21 March 2006

Mr. Robert Lewis, Chief
Transportation and Storage Safety
and Inspection Section
Spent Fuel Project Office
Office of Nuclear Material Safety and Safeguards
U.S. Nuclear Regulatory Commission
Washington, DC 20555-0001

Procedure	QA Program for 20WC Users
Revision	1
Date	March 2006
Approval	Jerry P. Wiza, President

RAM Services, Inc.
Specification 20WC Protective Wooden Jacket
Quality Assurance Program

Figure 1. RAM Services QA Organization

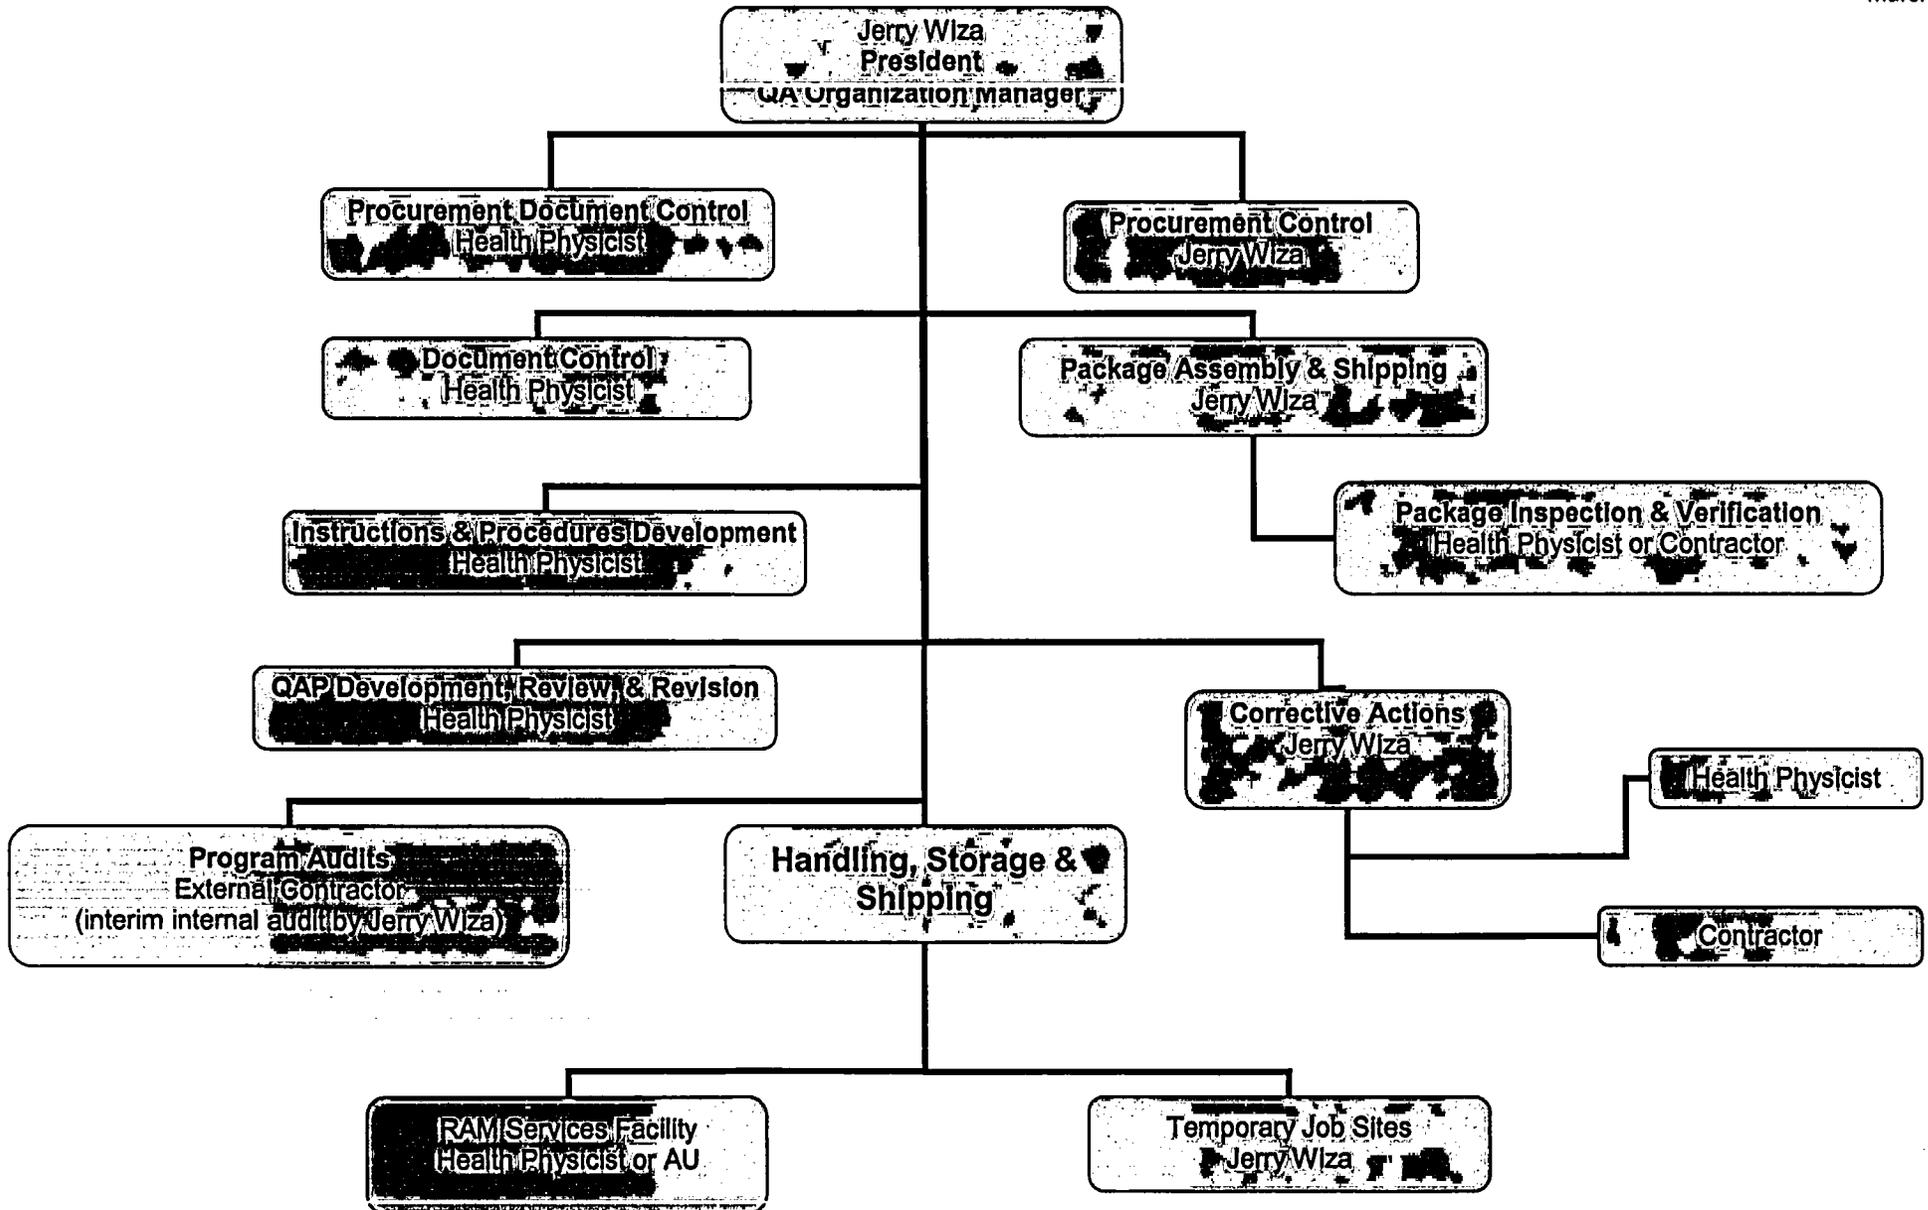
Question 1. Organizational Structure.

We concur that having one person attempt to perform all the QA functions, as well as prepare the package, is inadvisable and contrary to the clear intent of 10 CFR 71.103(d).

Consequently, we have substantially revised our program in order to distribute Quality Assurance Program [QAP] functions between the President of RAM Services and his professional staff, a health physicist. We have tried to observe the principle that “[c]onformance to established requirements is verified by individuals and groups that are not directly responsible for performing the work.” [Reg. Guide 7.10, Rev. 2, at p. 5].

We have prepared an expanded organization chart [QAP-1-1, which is also incorporated into our revised Quality Assurance Program, [QAP-2-1], submission, to delineate the re-distribution of responsibilities, which is discussed extensively in Section 1 of the revised program.
